CITY OF ALBUQUERQUE

December 27, 2021

**RE: The Wymont
4315 Wyoming Blvd NE
Grading and Drainage Plans
Engineer's Stamp Date: 11/02/21
Hydrology File: G19D004**

Based upon the information provided in your submittal received 11/01/2021, the Grading & Drainage Plan **is not** approved for Work Order and Grading Permit. The following comments need to be addressed for approval of the above referenced project:

RONALD R. BOHANNAN P.E. #7868	THE WYMONT ALBUQUERQUE, NM	DRAWN BY pm
	GRADING AND DRAINAGE PLAN	DATE 11-2-21
	TIERRA WEST, LLC 5571 MIDWAY PARK PL NE ALBUQUERQUE, NEW MEXICO 87109 (505) 858-3100 www.tierrawestllc.com	DRAWING 2021008-GR
		SHEET # GR-1
		JOB # 2021008

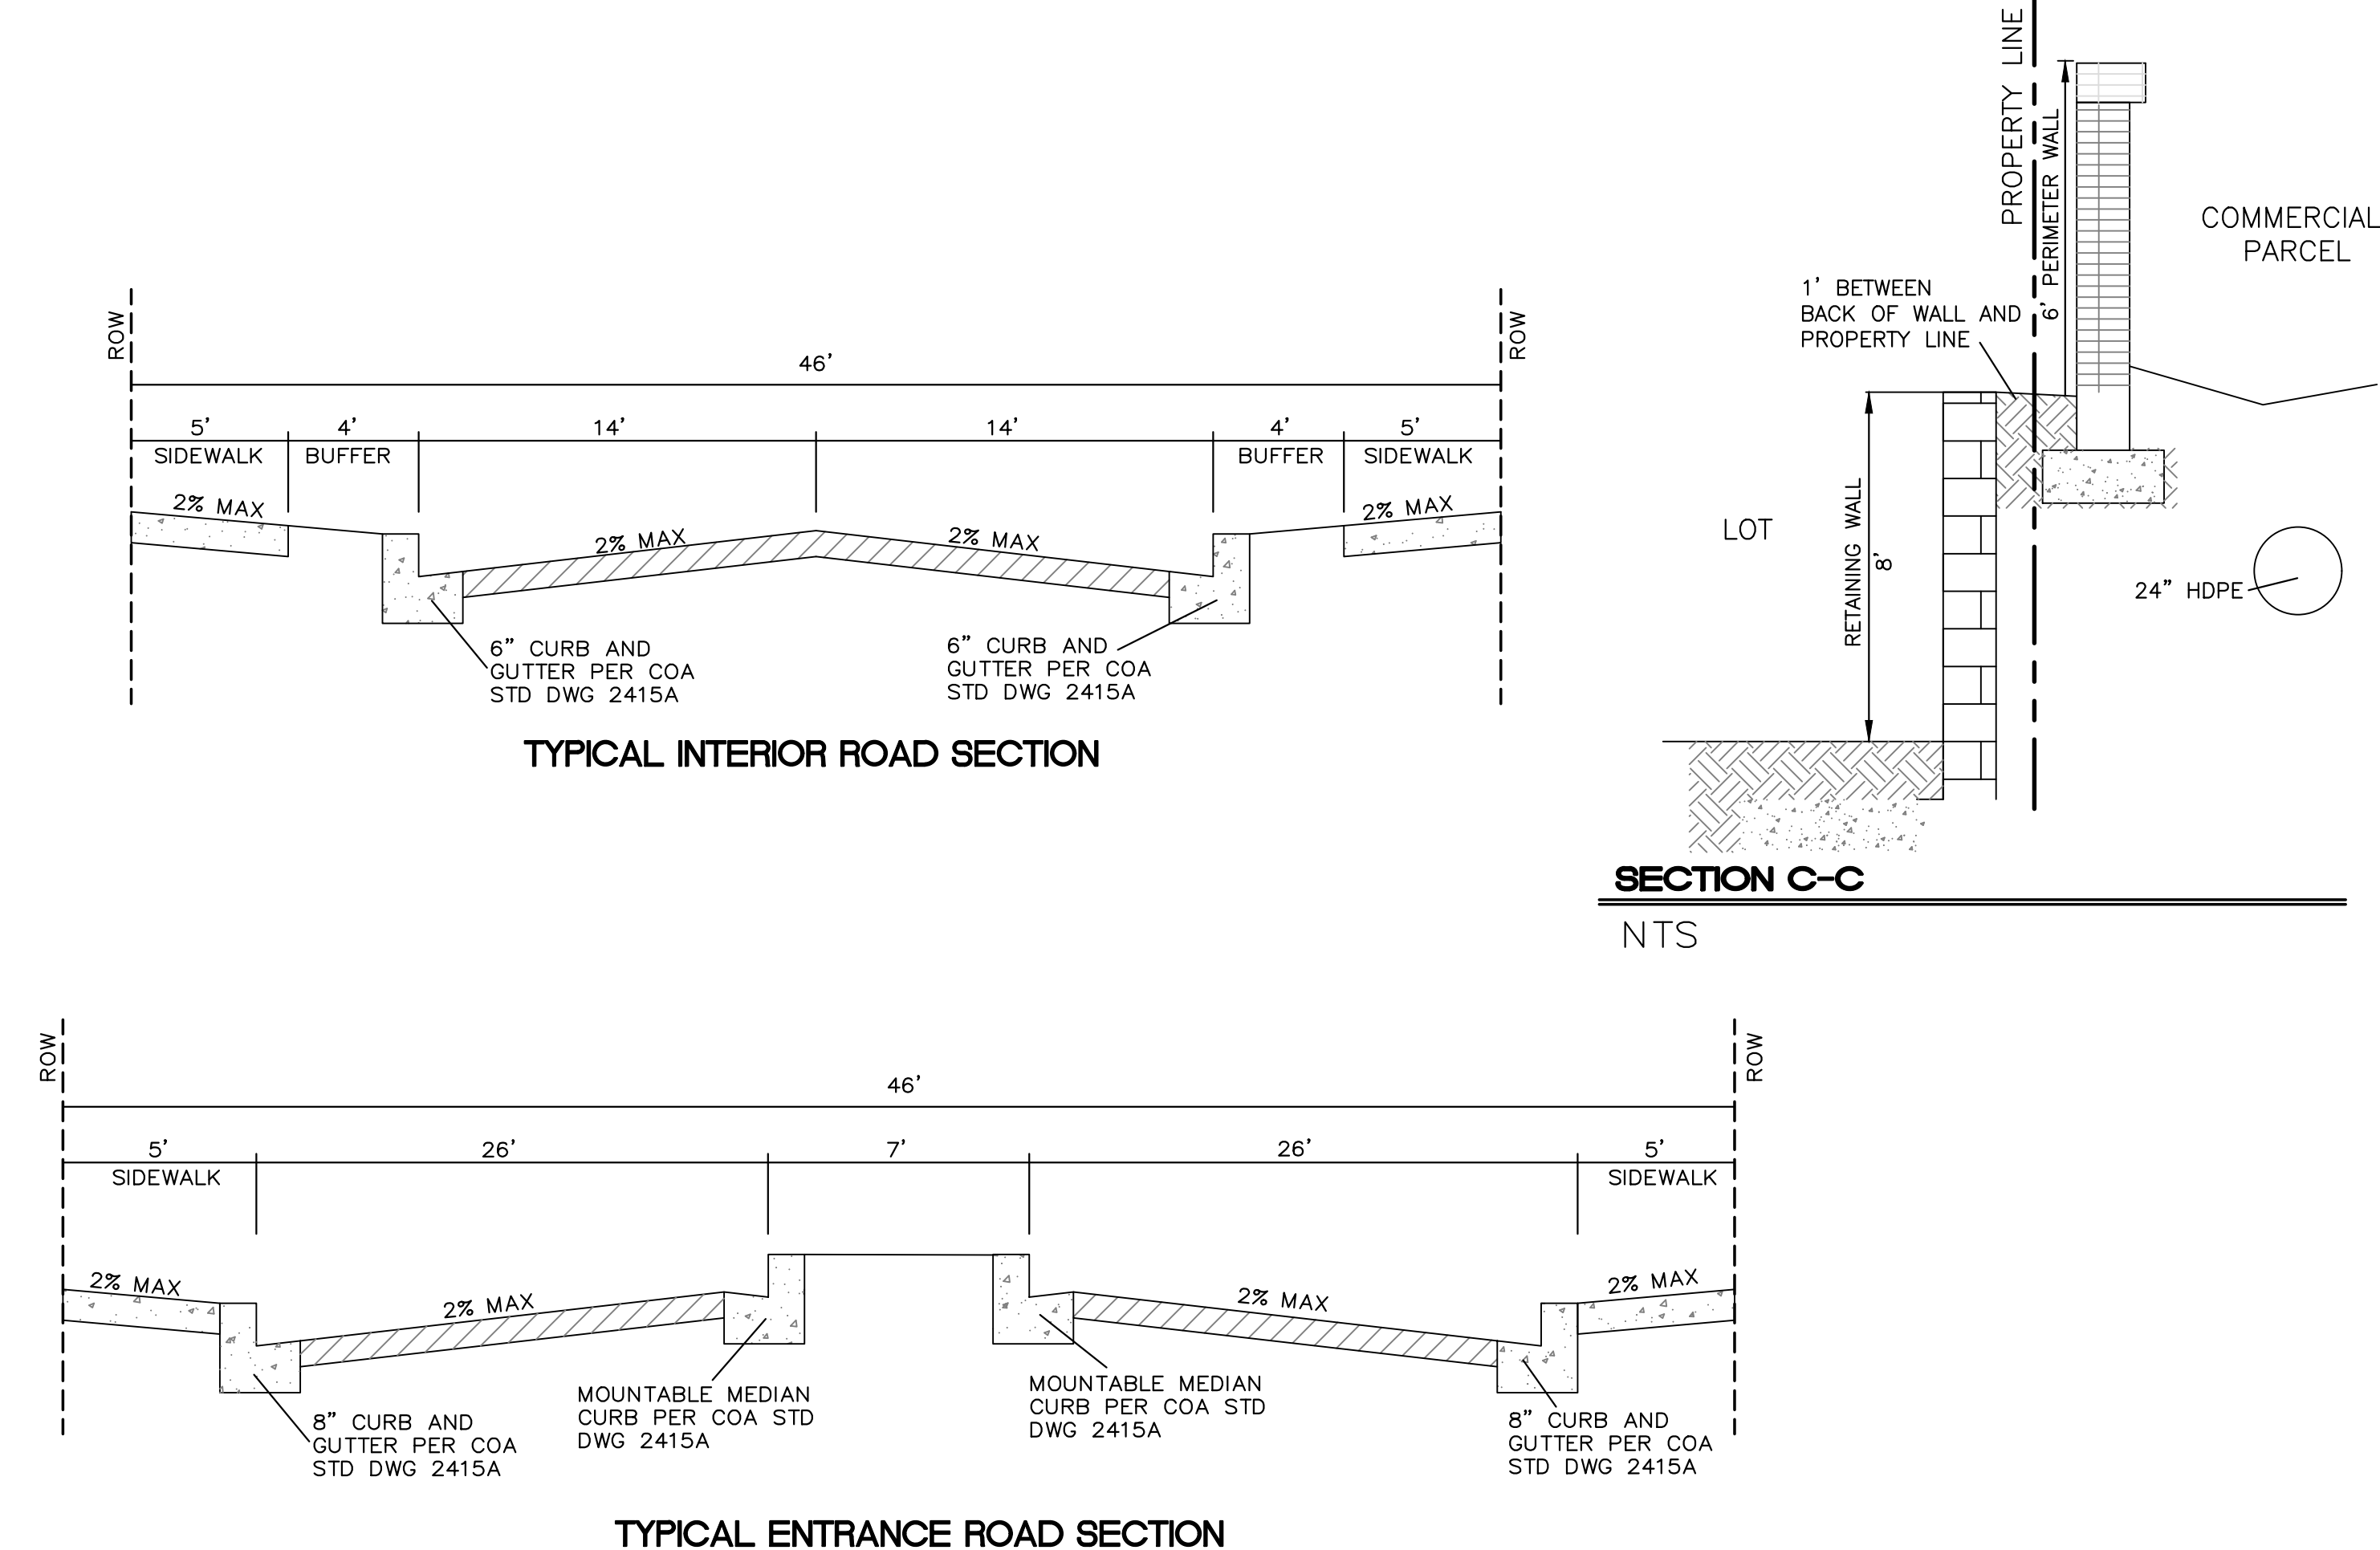
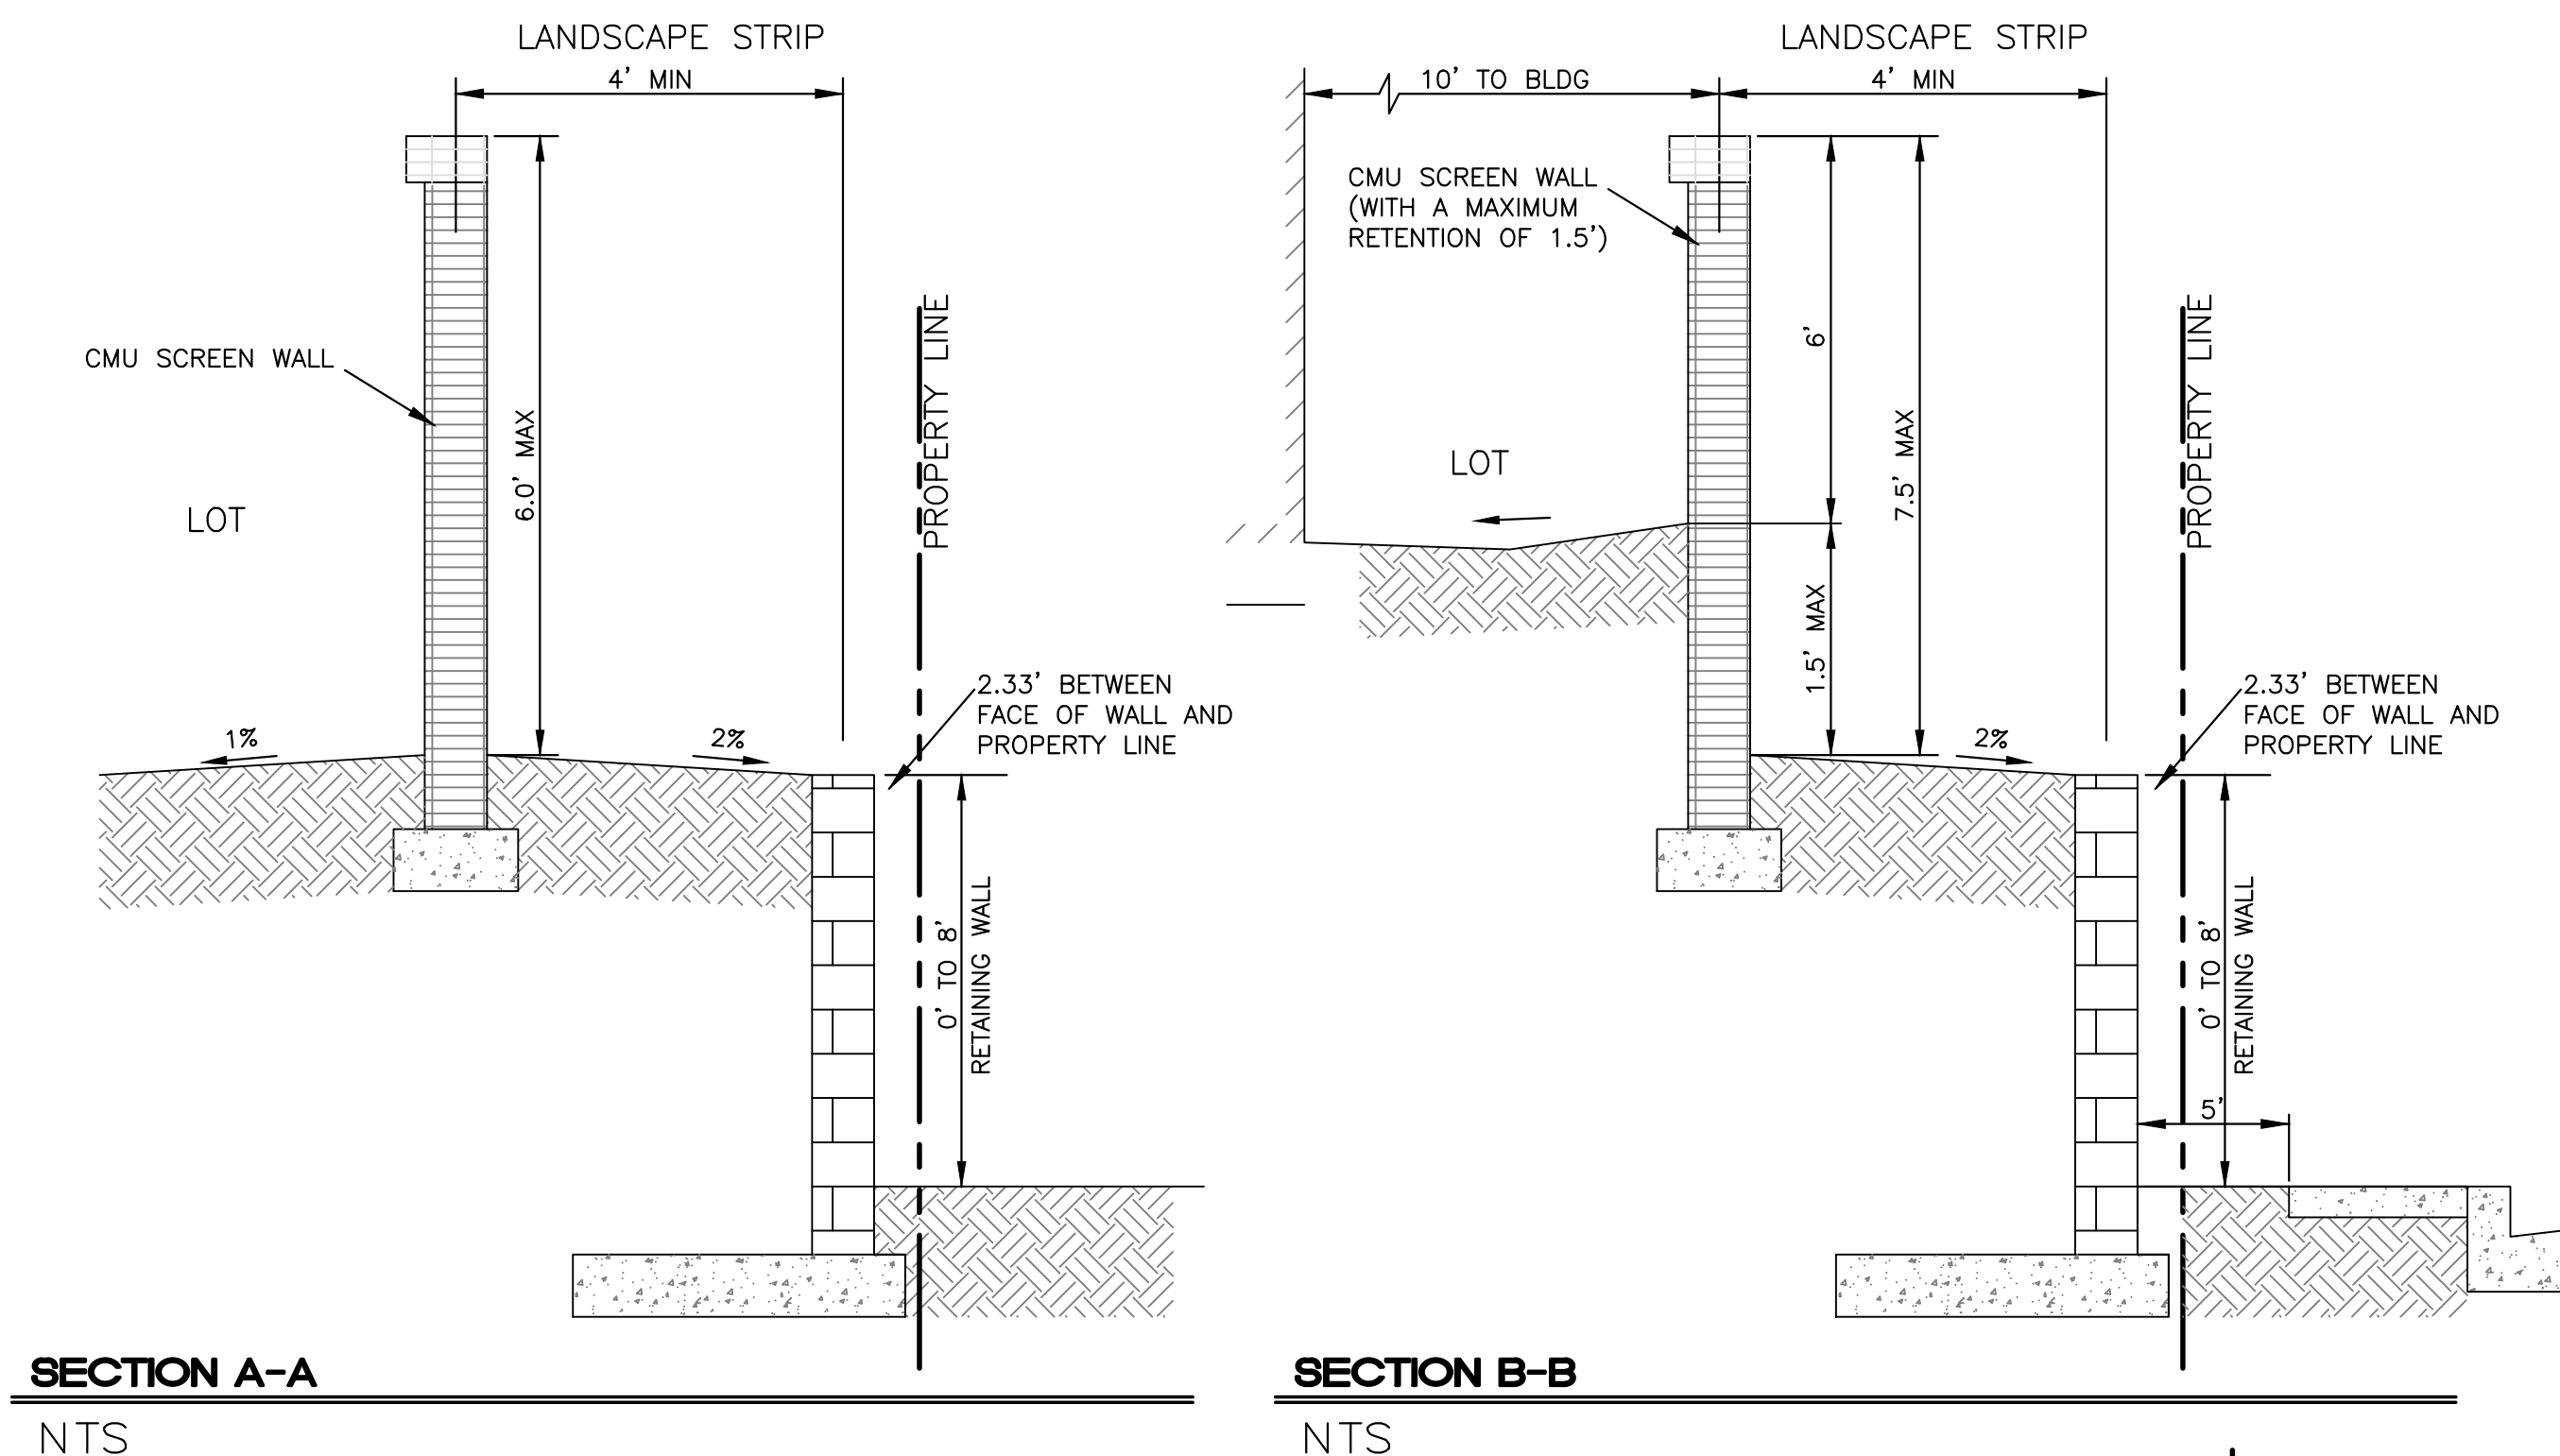
3. GR-1. This is currently very congested and difficult to read. Please, make this sheet just an overall Grading Plan with added pipe sizes, detention pond labeled, proposed contours, and line work with text showing which pipes and grading are to be done under which of the two work orders.

4. GR-1. Please add a note, "Side slopes need to be stabilized with Native Grass Seed (per City Spec 1012) with Aggregate Mulch or equal (Must satisfy the "Final Stabilization criteria" CGP 2.2.14.b.)". This is for the water quality pond.
5. Please make two Grading Plans at 1" = 20'. This will make the grading more readable and less congested.
6. GR-2. As with comment #4, this should be two storm pipe plans at 1" = 20'. Please add the word "Privately maintained" to all on-site storm pipes. This will also include the 24" RCP from the pond outfall structure to the new manhole in La Mirada Lane.
7. GR-3. Please relabel this as Master Drainage Plan.
8. GR-3. The Existing Drainage Area "A" drains to the west and then to the southwest as shown.
